Proposal for amendments to the Consolidated Resolution

Proposal for amendment 6 to the Consolidated Resolution on the common specification of light source categories (R.E.5)

Submitted by the Working Party on Lighting and Light-Signalling*, **

Figure 4

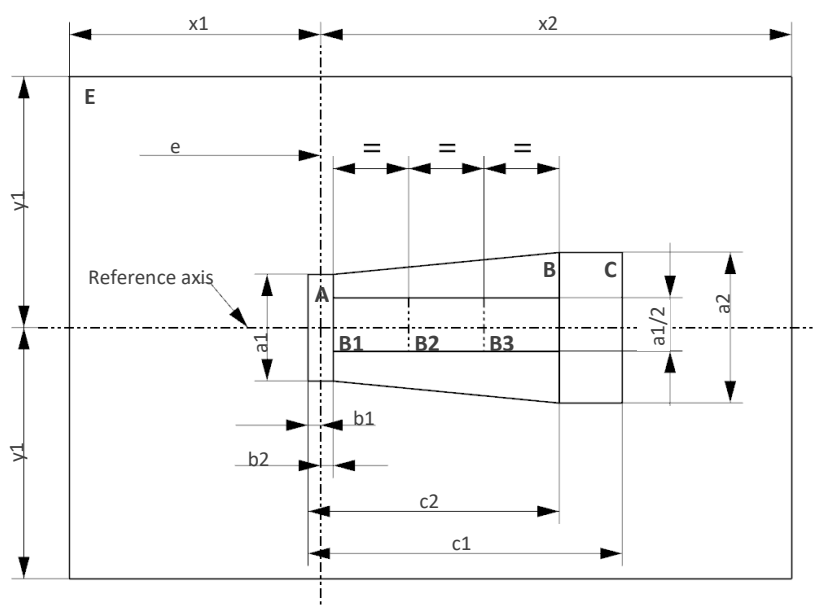
The position of the light emitting area is checked by a box system defined in Figure 4 when operated at test voltage, which shows the projections when viewing from B (see sheet H11/LED/1, Figure 1) and from A and –A (see sheet H11/LED/1, Figure 1), i.e. along the C-planes C_0 , C_{90} and C_{270} (as defined in Figure 6).

- Total box area: $(A+B+C) / E$ shall be not less than 90%
(for standard light sources a minimum of 95% applies)
- Area A: $A / (A+B+C)$ shall be not more than 10%
- Areas B_1 , B_2 and B_3 : B_1/B , B_2/B , B_3/B shall each be not less than 15%
- Area B: $B / (A+B+C)$ shall be not less than 72 %
(for standard light sources a minimum of 75% and a maximum of 85% applies)
- Area C: $C / (A+B+C)$ shall be not more than 22%

Figure 5
Box definition of the area D (dimensions given in Table 2)

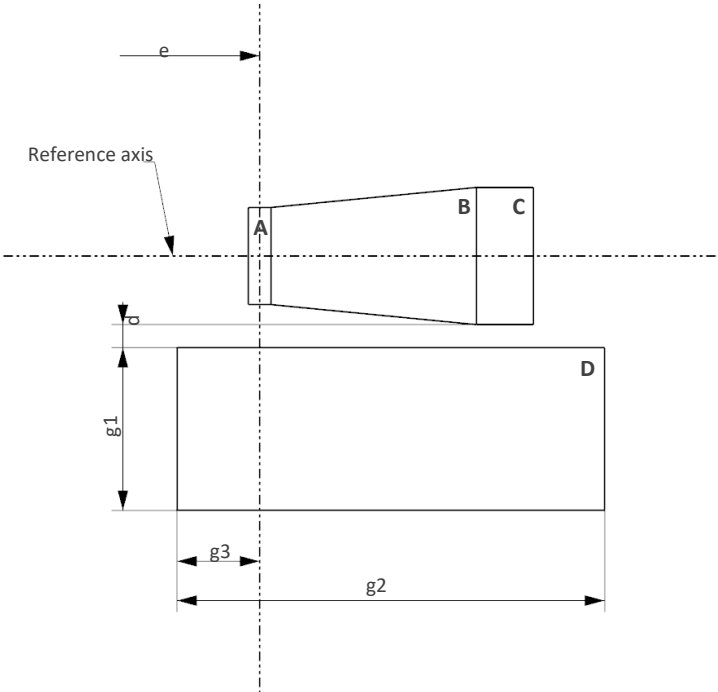
The contrast is checked by a box system defined in Figure 5 when operated at test voltage, which shows the projections when viewing from A and –A (see sheet H11/LED/1, Figure 1), i.e. along the C-planes C_{90} and C_{270} (as defined in Figure 6).

The contrast is the proportion of the total luminous flux values emitted into these viewing directions from the corresponding areas $(A+B+C)$ and D. The value of the contrast $(A+B+C) / D$ shall be within the limits given in Table 1 (see Figure 5 for the definition of the area D).

Figure 6

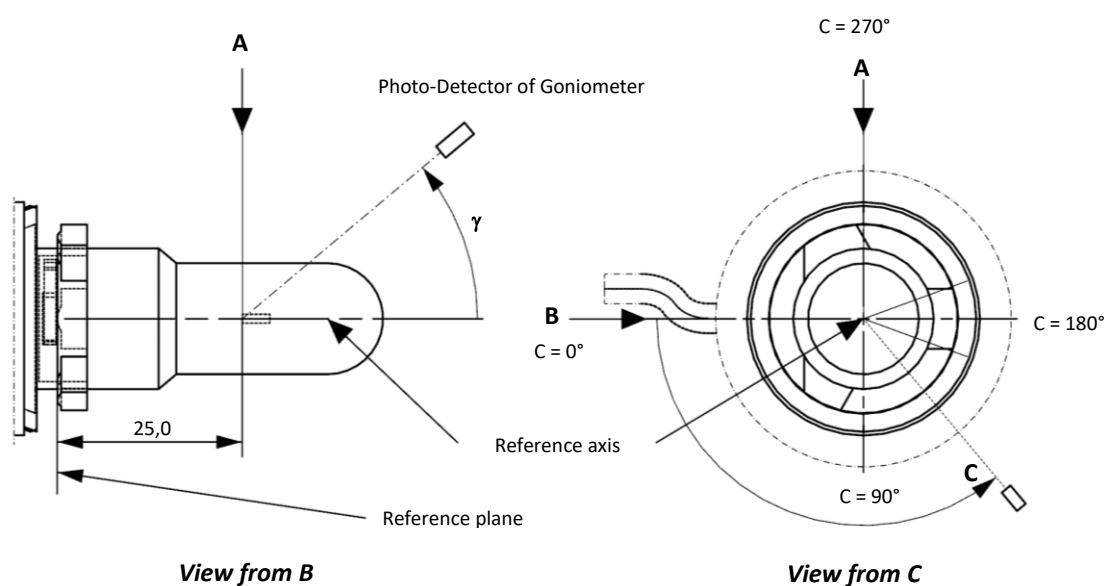
The following test is intended to determine the normalized luminous intensity distribution of the light source in the C-planes as described in Figure 6 when operated at test voltage. The intersection of the reference axis and the plane parallel to the reference plane at distance $e = 25.0$ mm is used as the coordinate system origin.

The measured luminous intensity values, normalised to the measured luminous flux of the individual light source under test, shall be converted to normalised luminous intensity values of a 1000 lm light source. These data shall comply with the limits as defined in Table 3.
